Letter of Transmittal

Date: 4-7-2026
Petition Map: 26-27

DRAWN BY	LC	REQUEST ENCROACHMENT INTO THE ALLEY BOUNDED BY W. GRAND BLVD., LAWTON ST., FERRY PARK AVE., AND LINWOOD ST.	CITY OF DETROIT
DATE	03/26/2026		CITY ENGINEERING DIVISION
CHECKED	AP		MAPS & RECORDS BUREAU
APPROVED	GE		JOB NO. 26-27
			DRWG.NO.

FIVE (5.00) FOOT WIDE STORM SEWER ENCROACHMENT (COVER LETTER)

FIVE (5.00) FOOT WIDE STORM SEWER ENCROACHMENT (MAP OF ENCROACHMENT)

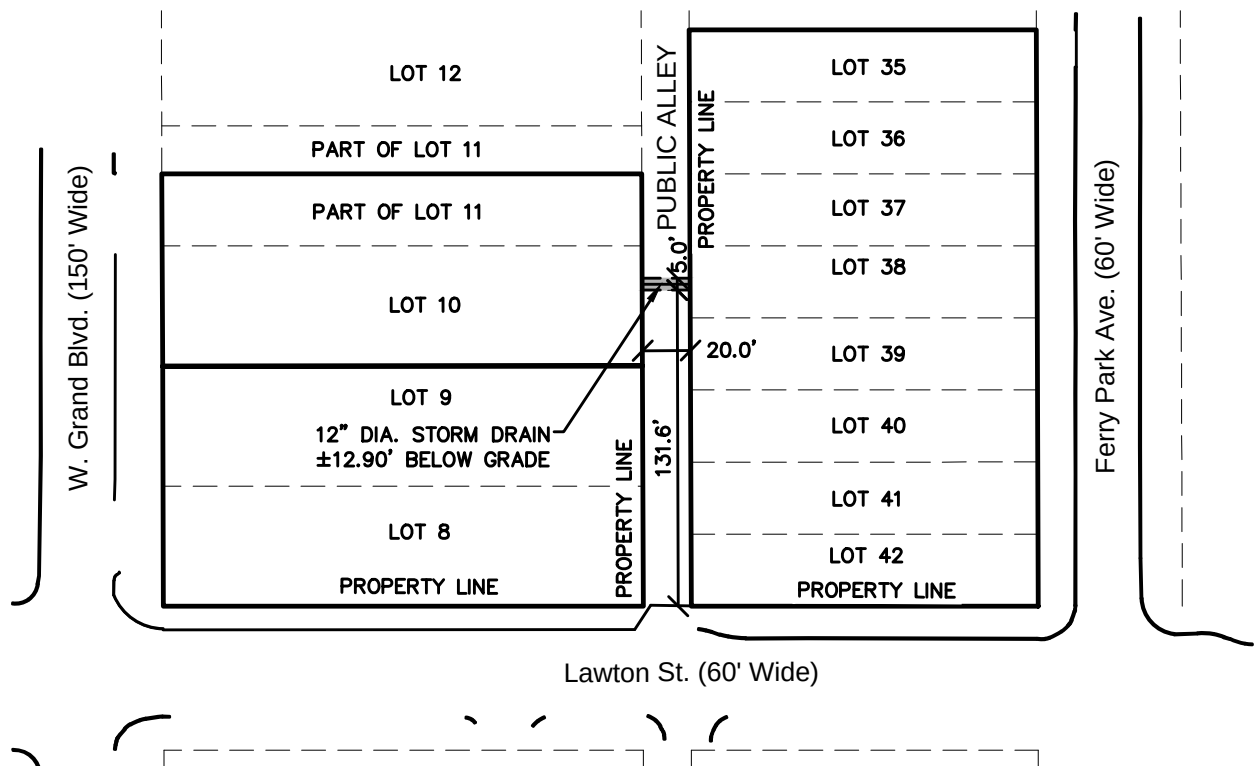
NOTE: DWSD records show that there is an existing 12" sewer located in the alley approx.12 feet below the ground surface, to meet the Detroit Water and Sewerage Department (DWSD) requirement to maintain the mandatory 18-inch (1.5 ft) vertical clearance while crossing perpendicularly the depth of your proposed 12" storm sewer needs to be adjusted.
